CAPITOL BUILDING ADVISORY COMMITTEE

November 20, 2012

ARMENIAN MEMORIAL GARDEN LANDSCAPE PLAN

ARMENIAN MEMORIAL GARDEN
LANDSCAPE PLAN
State Capitol
Denver, Colorado

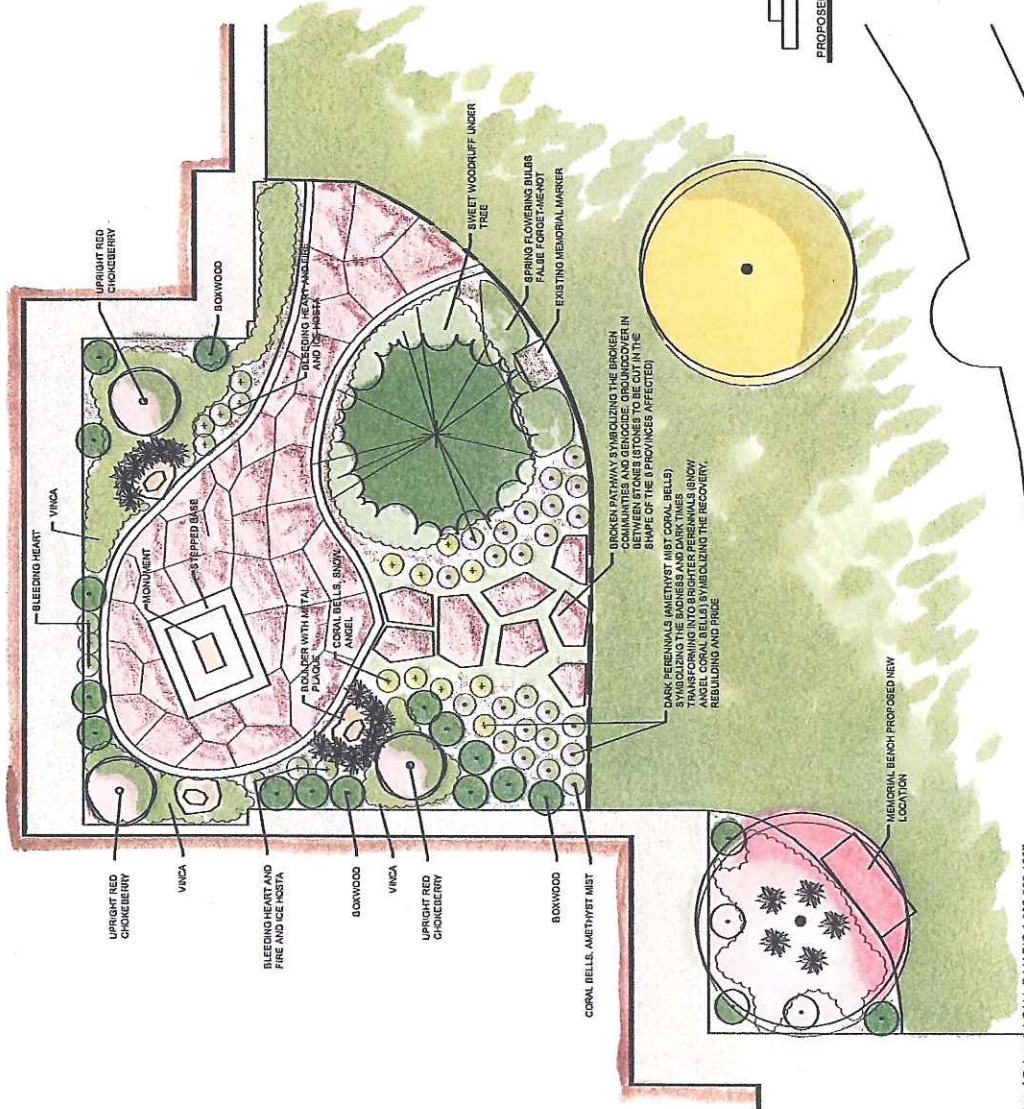
On November 16, 2012, the advisory committee approved a design for the Armenian Garden. The approved design is attached. The advisory committee approved the design contingent upon the following design modifications:

- the height of the khachkar will not exceed five feet, excluding the base footing;
- the khachkar will be placed at a 45 degree angle to the walls of the Capitol;
- the pavers on the finished paths (with the exception of the "broken" path) should be in a regular pattern, similar to the existing pavers on the east side of the Capitol, to facilitate accessibility; and
- consideration should be given to including a foot path to the garden from the existing sidewalk to the east stairs of the Capitol, and to lighting the garden from above.

Additionally, the advisory committee asked the building architect to consult with Colorado State Patrol before the CDC considers the approved design to see if any modifications are necessary to improve security. The advisory committee also requested that Capitol Complex and the Armenians of Colorado seek to develop a letter of agreement regarding future responsibility for ongoing maintenance of the garden. A plaque explaining the significance of the khachkar was included in
